REGIONAL REVIEW NOTIFICATION

Name of Proposal: Southpoint Mall

Review Type: Development of Regional Impact

Preliminary Report:	September 26, 2005	DEVELOPMENT OF REGIONAL IMPACT REVIEW REPORT	Project:	South Point #902
Final Report Due:	October 26, 2005		Comments Due By:	October 10, 2005

PRELIMINARY
SITE PLAN

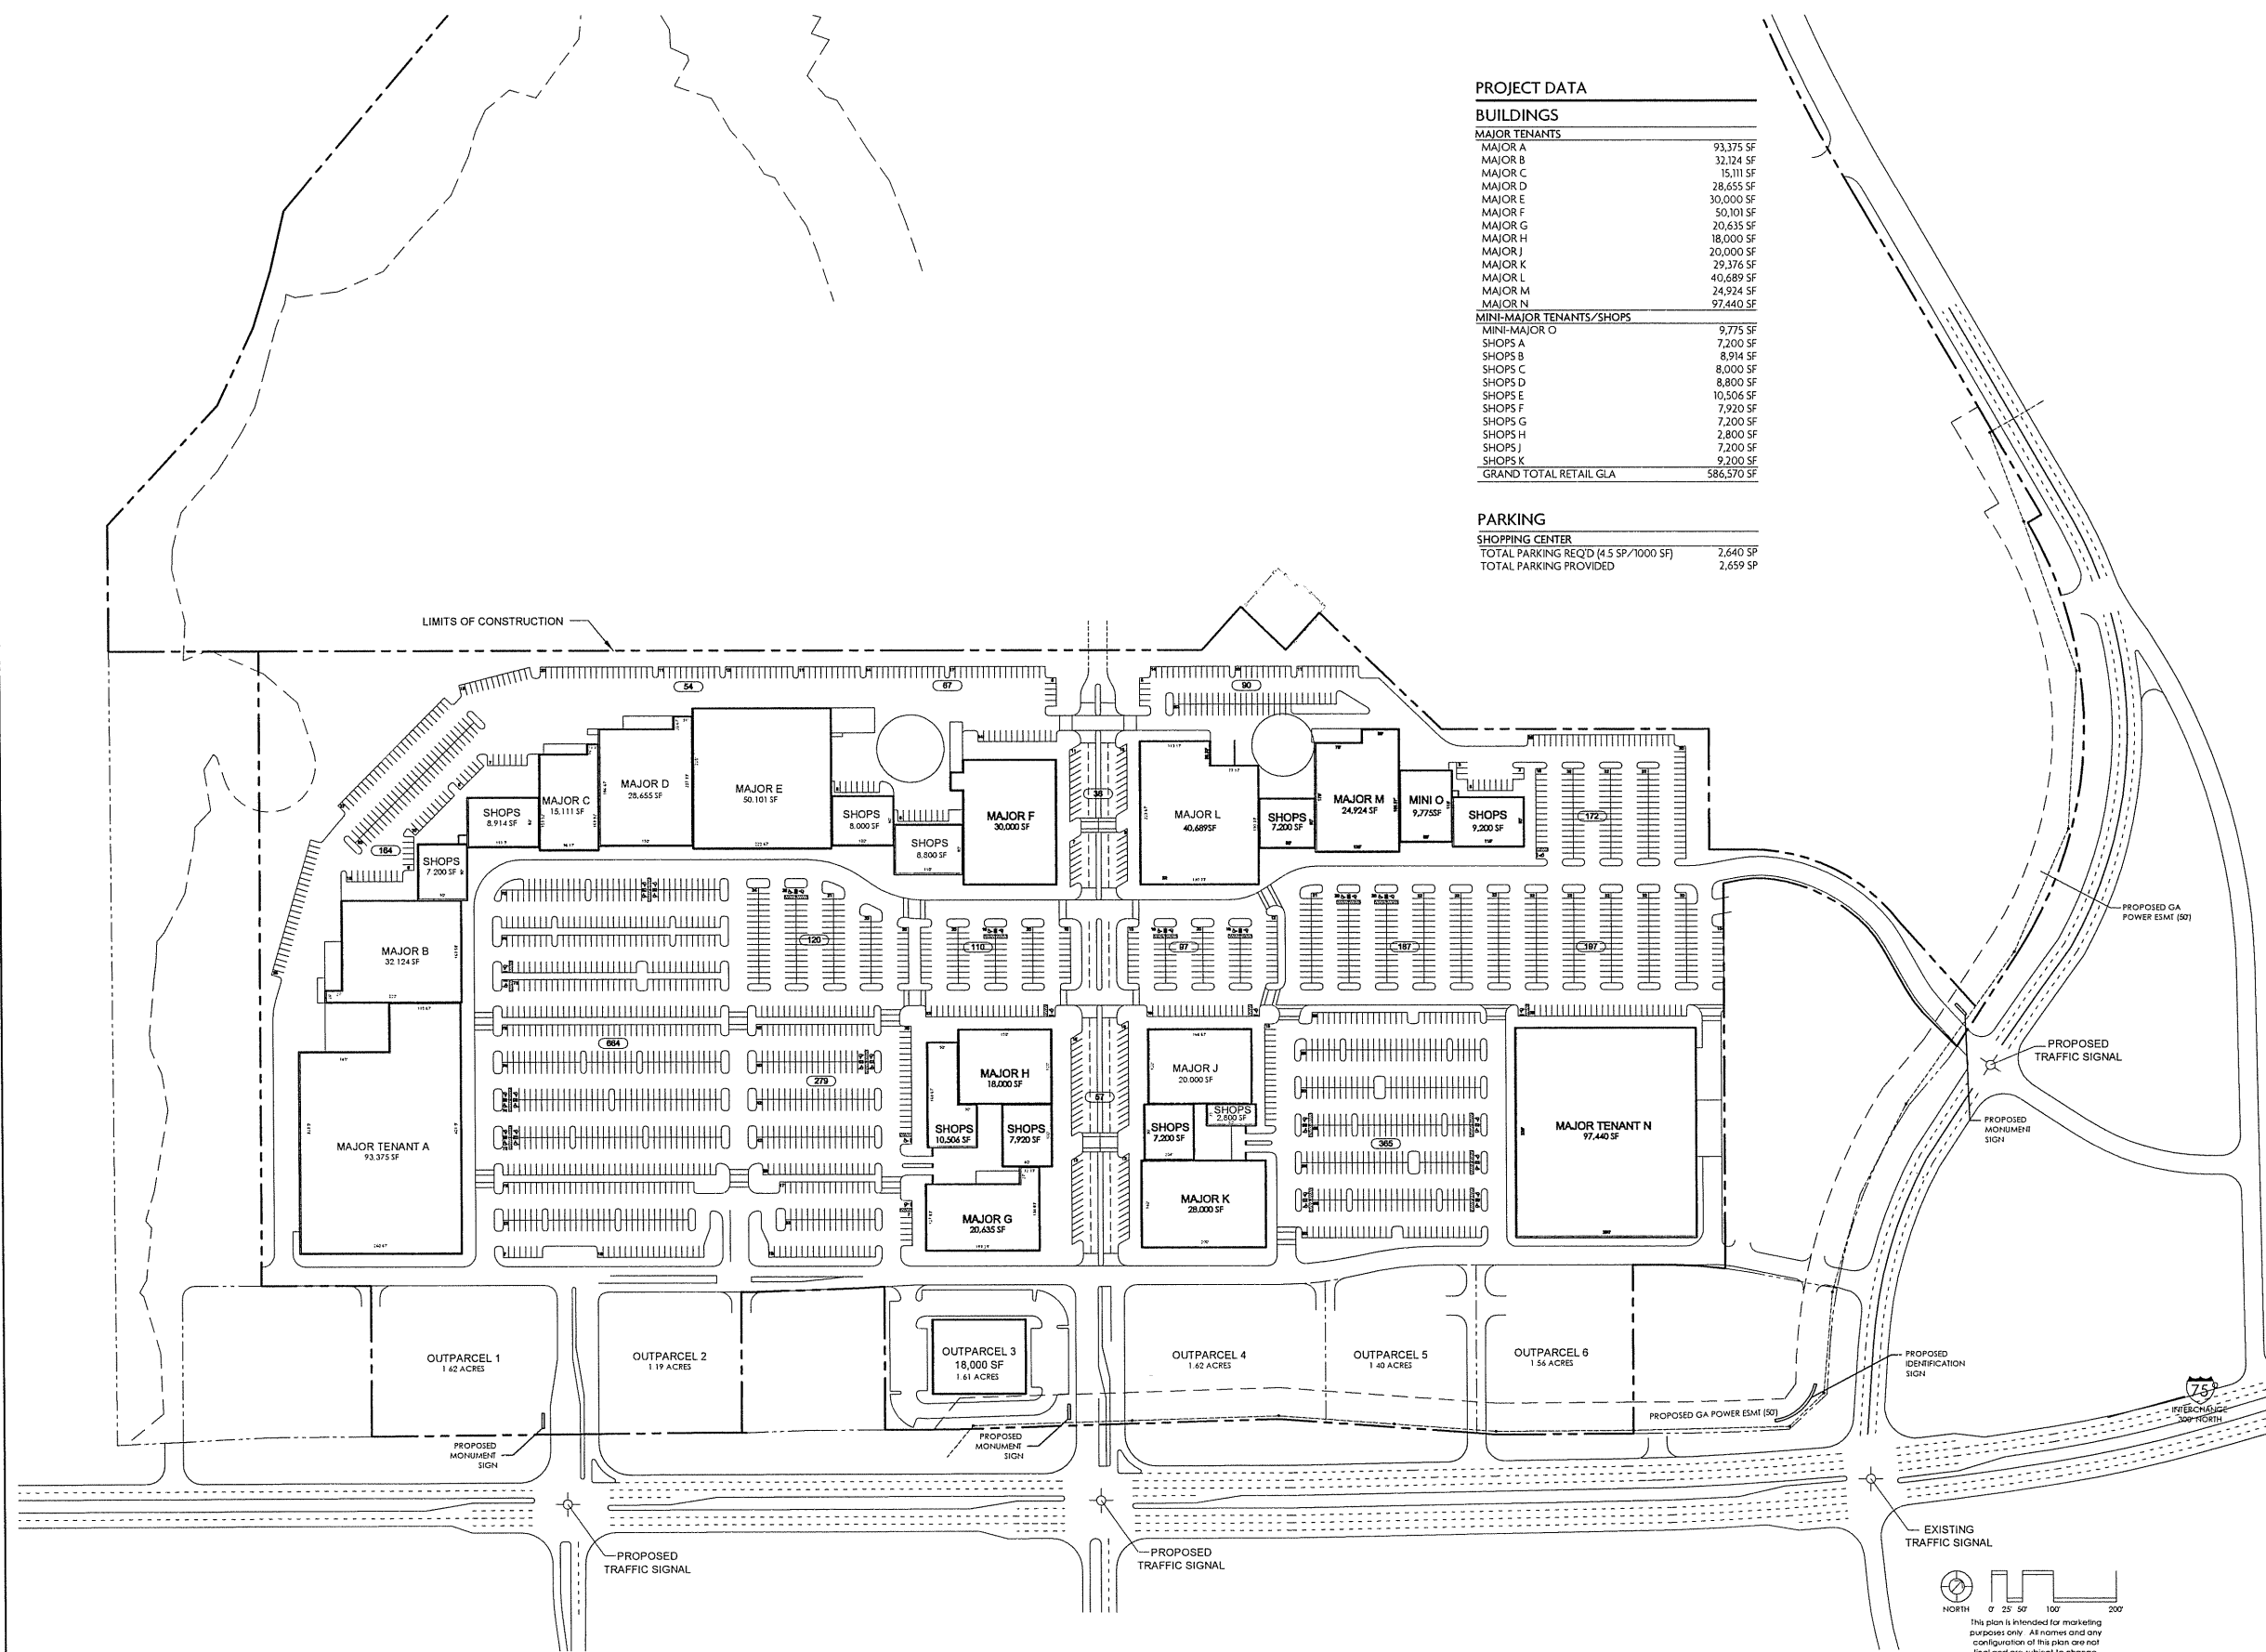
City of McDonough should consider several design standards, as well as the architectural design standards being proposed in the downtown core by the LCI study. The outparcels along Hwy 20 should not be allowed direct access onto Hwy 20 or Roads A, B, and C. Access to the outparcels should be from Road D, as seen on the site plan for outparcel 3. Road D should be built to the city/county road standards with a stub out for future connectivity into any future development that may occur west of the property along Hwy 20. Road L should also be built to city/county road standards. The 130 parking spaces located along Road L should be removed to allow for clear movement of traffic. Road B should also be built to city/county road standards and should be considered the major access point for any future development that may occur north of the property. A stub out should be included at the end of the road into the undeveloped land owned by Richfield 81 Partners, LLC. Finally, Road E should be built to city/county road standards and connect through the development to the undeveloped land to the west.

The current site plan does not clearly indicate how stormwater runoff will be managed. In order to address post-construction stormwater runoff quality and quantity, the project should implement stormwater management controls (structural and/or nonstructural) as found in the Georgia Stormwater Management Manual (www.georgiastormwater.com) and meet the stormwater management quantity and quality criteria outlined in the Manual.
